Re: Information Request – RL/64/2026

Property: 12–16 Braddon Street and 223 California Creek Road, Cornubia

Proposal: Reconfiguring a Lot (Boundary Realignment)

This response addresses Item 1.1 regarding the proximity of the proposed boundary to the existing waterbody and the provision of space for maintenance works.

Figure: Annotated Preliminary Plan of Survey

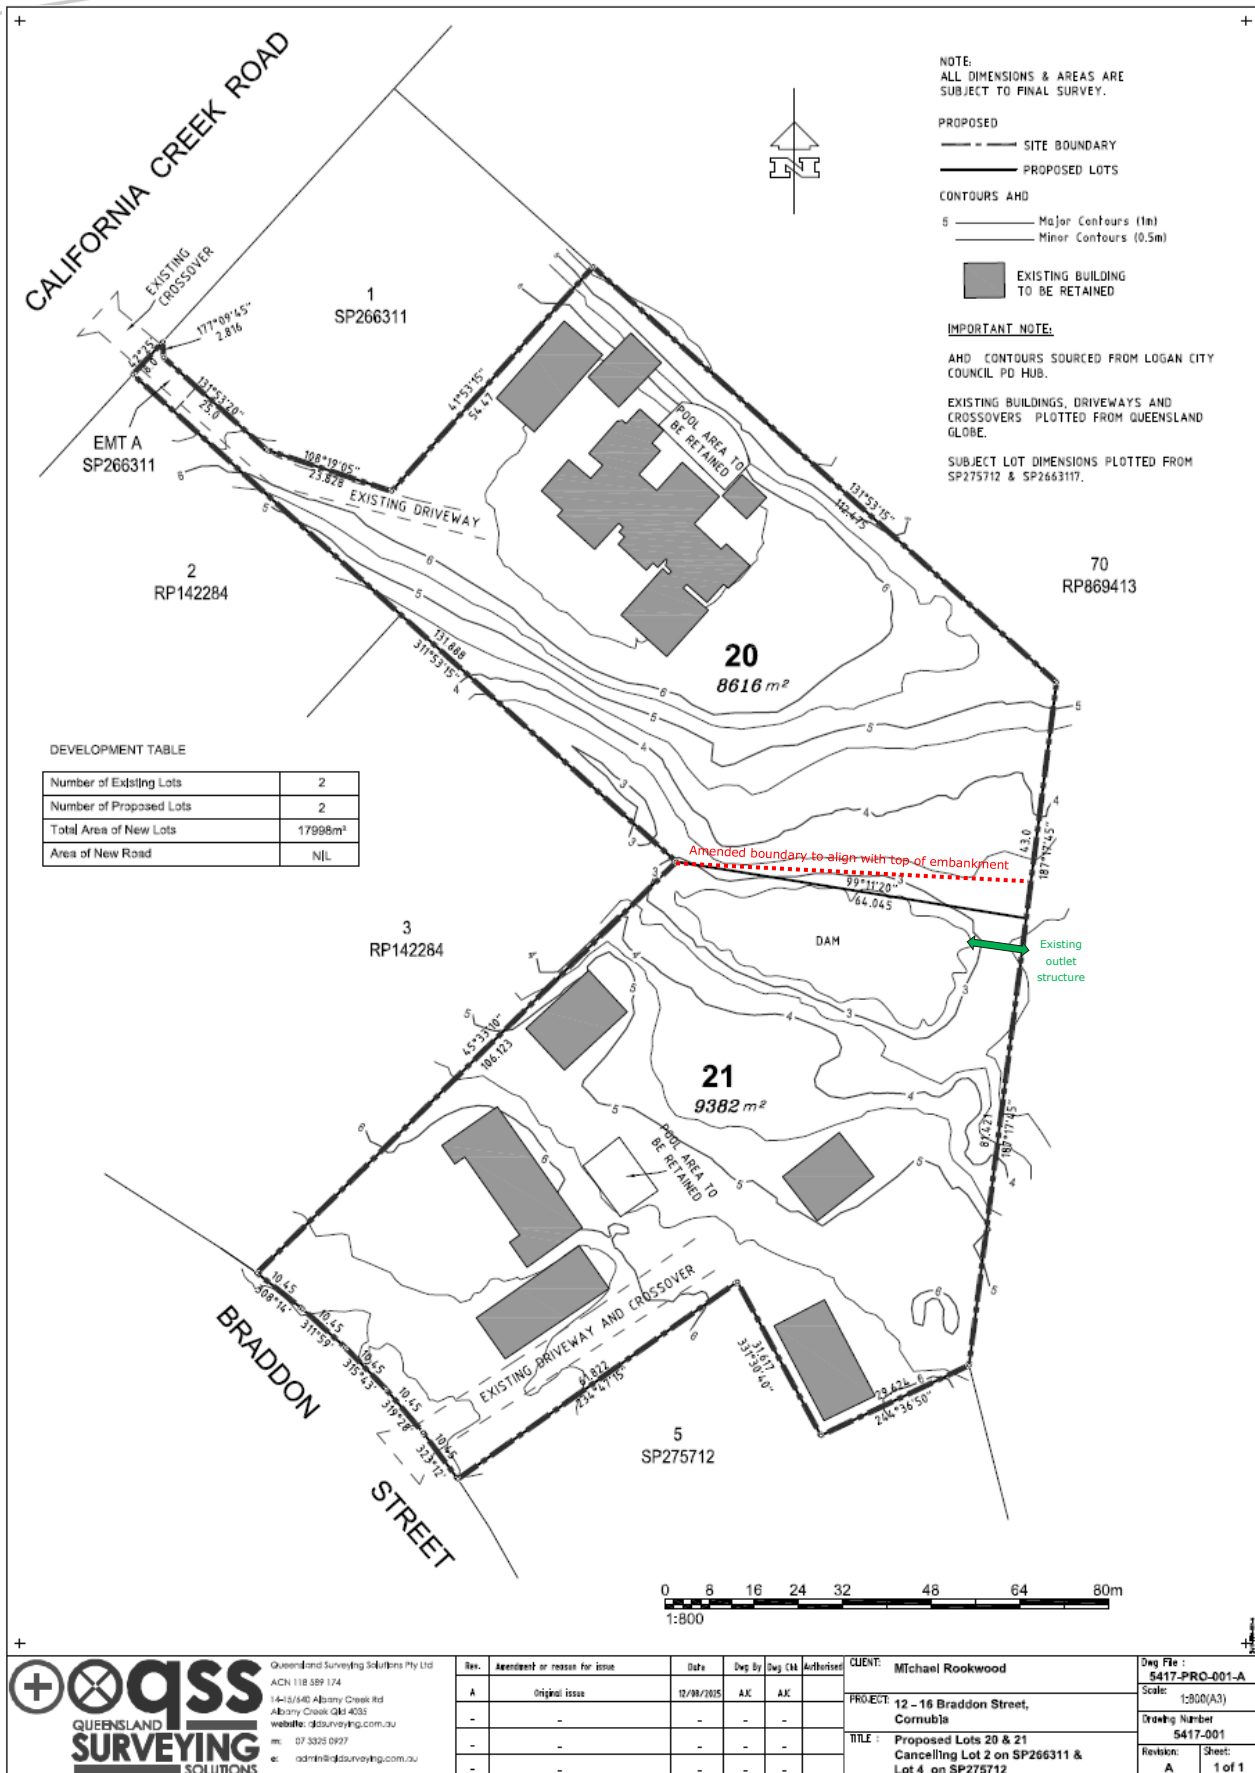
In order to alleviate any concerns regarding the future maintenance of the dam, we are willing to adjust the proposed boundary to ensure the entire dam to the top of the embankment is included in proposed lot 21, with the new boundary not closer than 3 metres from the outlet structure to facilitate any further maintenance works, as illustrated in the figure enclosed.

The amendment to the proposed new boundary results in the area subject the realignment being reduced from 2,248m² to ~2,148m² (-100m²).
